MIL-R-55504(EL)
Amendment 2
12 February 1970
Superseding
Amendment 1
19 September 1967

MILITARY SPECIFICATION

RECEIVER, RADIO R-1041B/ARN

This Amendment forms a part of MIL-R-55504(EL), 25 January 1967.

FIGURE 2

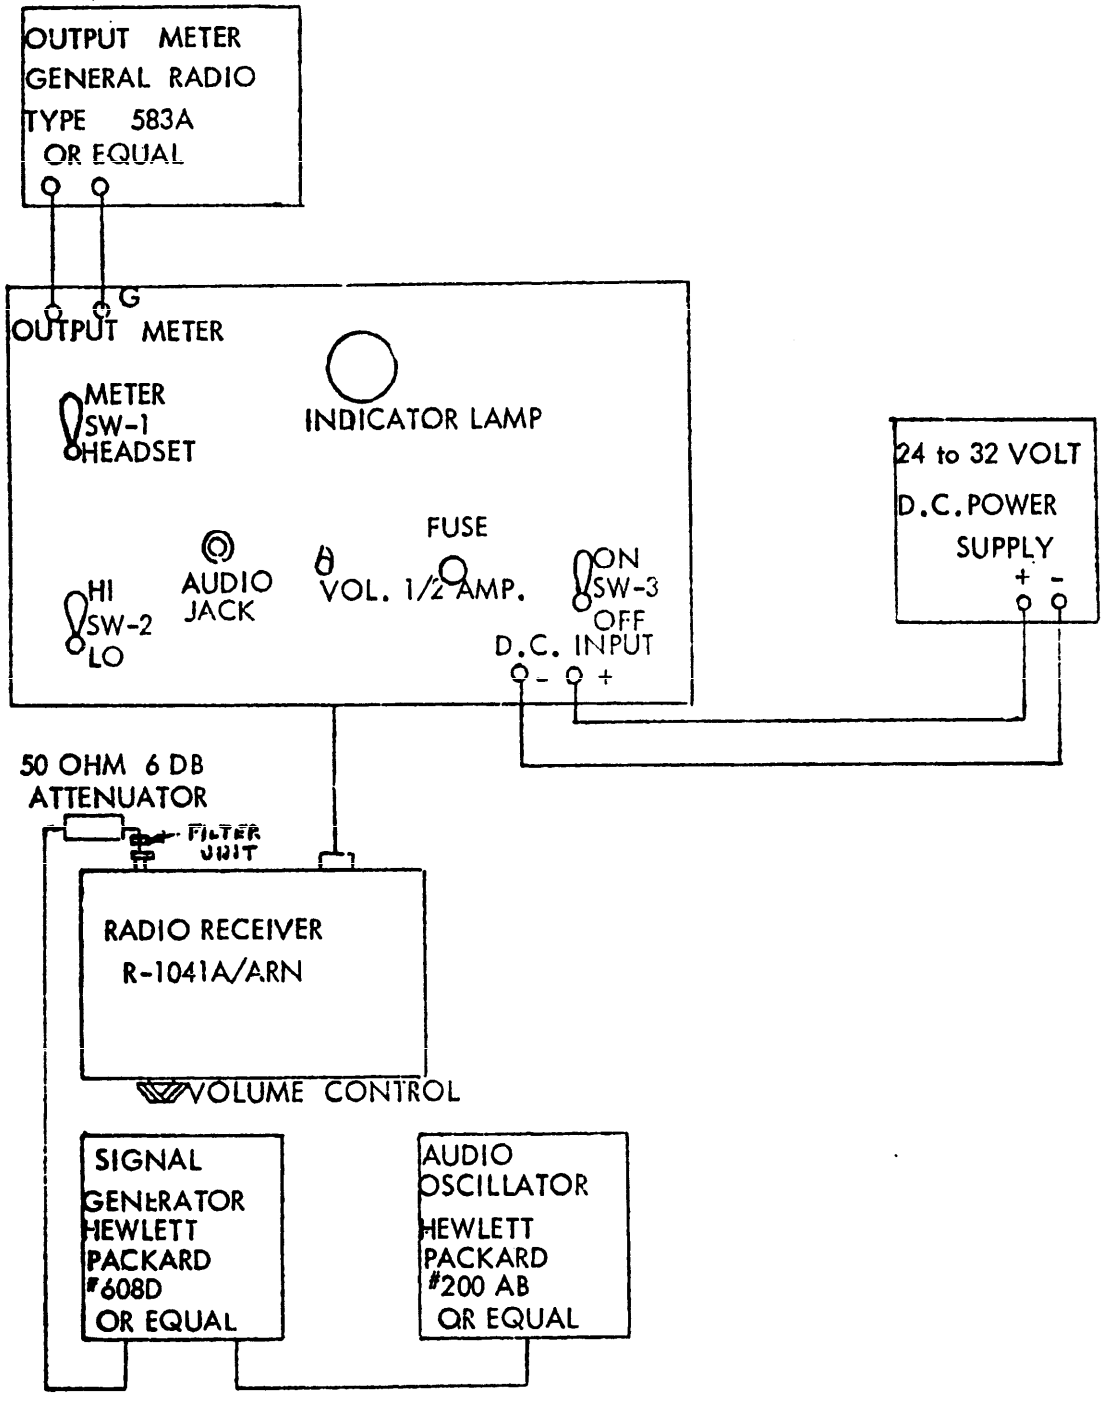
13. Paragraph 3.9.15 Spurious response, on the eighth line down, after last sentence add: "In performing spurious tests lowpass filter units shall be used between the RF Signal Generator Output and the R-1041B/ARN input in conformance with MIL-STD-461A, 31 July 1967 which reiterates paragraph 4.3.4.5 of Specification MIL-D-6181D. These filters shall at least attenuate the 75 MHz HP 608D Signal Generator signal beyond the 40 db capacity of the generator with cutoff at 49 MHz (See Figure 2)."

15. Use the Block Diagram, Figure 2, attached . instead of Figure 2 of MIL-R-55504(EL).
